# Planning Report

## Avondale Woods PUD

Subarea A (Lakeside at Avondale Woods), Subarea C (Section 1, Lots 1-24),  
and Subarea E

Agenda Item	2
Case Number	16-034FDP/FP
Proposal	To develop a residential subdivision containing 48 condominium units in 24 buildings within Subarea A, 24 single family lots within Subarea C, stormwater management and an entry feature in portions of Subarea E, and associated parks and open space within the Avondale Woods Planned Unit Development.
Request	Review and approval of a <u>minor modification to the development text</u> under the provisions of Zoning Code Section 153.050.  Review and approval of a <u>final development plan</u> under the provisions of Zoning Code Section 153.050.  Review and recommendation of approval to City Council of a <u>final plat</u> under the provisions of the Subdivision Regulations.
Site Location	West side of Avery Road approximately 1,000 feet south of the intersection with Rings Road.
Applicant	Jim Lipnos, President, Homewood Corporation, represented by Chris Cline, Blaugrund, Herbert, and Martin.

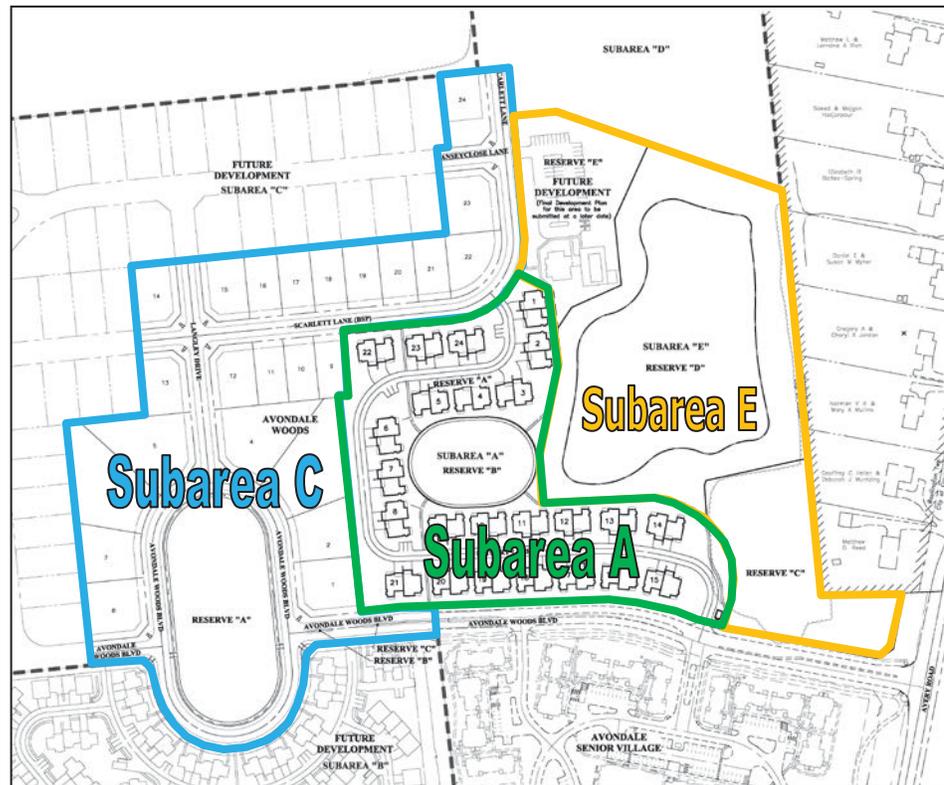
<b>Details</b>		<b>Final Development Plan</b>
Process	The final development plan conforms with and provides a detailed refinement of the approved preliminary development plan. The final development plan includes all of the final details of the proposed development and is the final stage of the PUD process.	
Proposal	This proposal is for the first phase of development for the Avondale Woods subdivision including the platting and development of 24 single-family lots, 48 condominium units designed as duplex structures, a stormwater pond servicing the entire subdivision, dedication of public open space, and the expansion and construction of four new public roadways. This application consists of three of the seven subareas located in the Avondale Woods PUD and prepares the site for future phases of development.	
Layout	This application contains Subarea A, Subarea C, and the majority of Subarea E of the Avondale Woods development, see site plan below. Subarea A is a

condominium community known as the Lakeside at Avondale Woods and contains a winding single private drive (Estuary Lane) that connects Avondale Woods Boulevard on the south to Scarlett Lane on the north. This Subarea contains 48 condominium units contained in 24 duplex buildings that site on either side of Estuary Lane. A one-acre green space is provided in the center of the community with a walking path located on the perimeter that connects to all of the adjacent units. An entry feature is proposed at each entrance and a total of nine visitor parking spaces are provided along Estuary Lane.
